1. PLUS Radios: HTP-900RE and HTP-900SEO

These sections describe the updates and known limitations in each software version for the HTP-900RE and HTP-900SEO PLUS Radios. The most recent version is listed first.

Figure 1: Security window - Reboot Interval list box

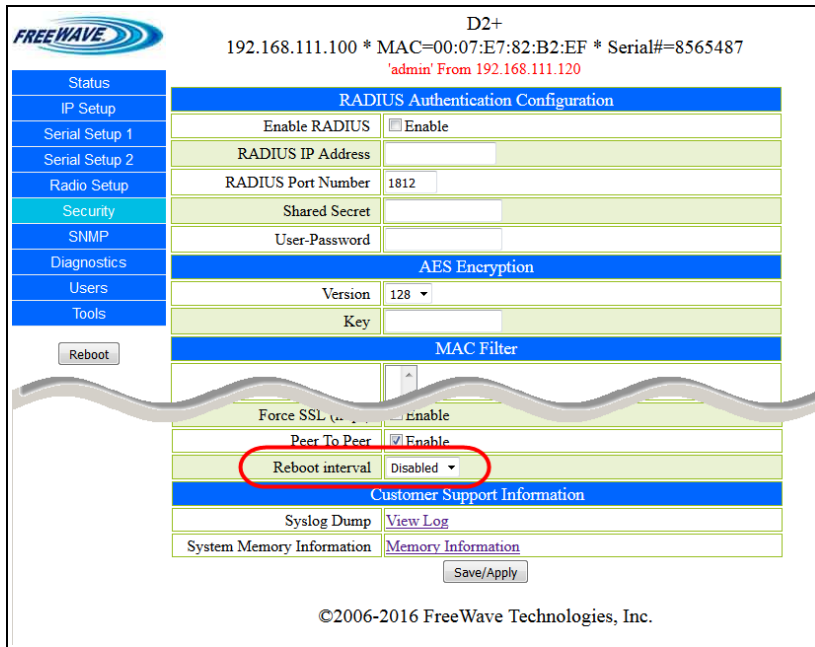
In the **Security** window, in the **Miscellaneous** area, a new **Reboot Interval** list box option has been added.

- By default, the **Reboot Interval** is **Disabled**.
 - If **Disabled** is selected, the PLUS Radio will operate without automatically rebooting.
 - When an interval (e.g., **1 Hour**, **1 Day**, **30 Days**) is selected, the scheduler automatically reboots the PLUS Radio when the reboot interval expires.
